## MEMORANDUM

DATE: October 26, 2022

RE: Kendall Toyota – Internal Illumination of Entry Wall – Determination of Architectural Harmony

# Illumination Study

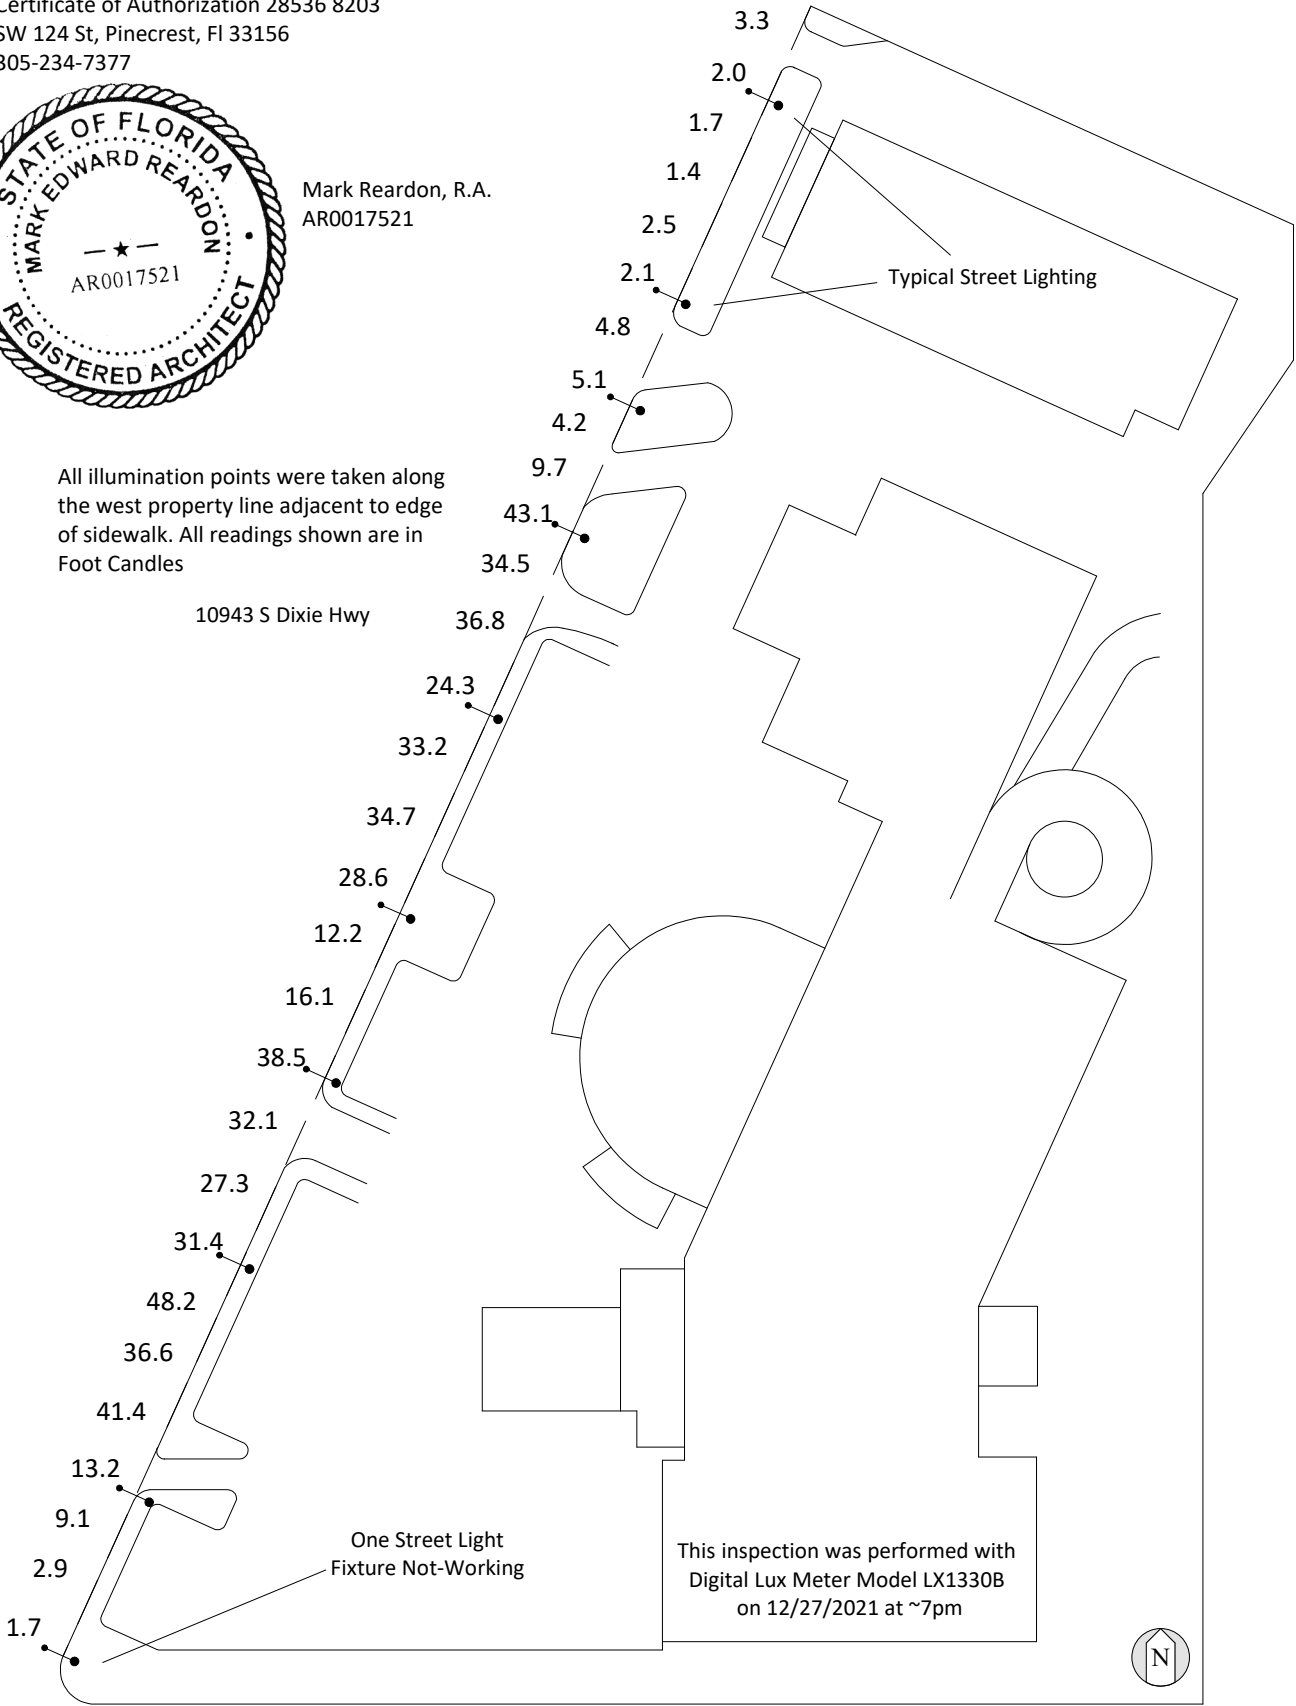
An Illumination Study, completed by Allied on December 27, 2021 (attached) confirmed lighting levels at the Kendall Toyota property line adjacent to Pinecrest Parkway to be as high as 48.2 foot-candles, or 96.4 times greater than otherwise permitted by code today. Additionally, a field inspection completed by the Building and Planning Department confirmed that several of the existing lights on the subject property are not shielded and are causing glare. Photographs showing lighting conditions on the subject property are provided on pages 7 and 8 of this report.

All illumination points were taken along the west property line adjacent to edge of sidewalk. All readings shown are in Foot Candles
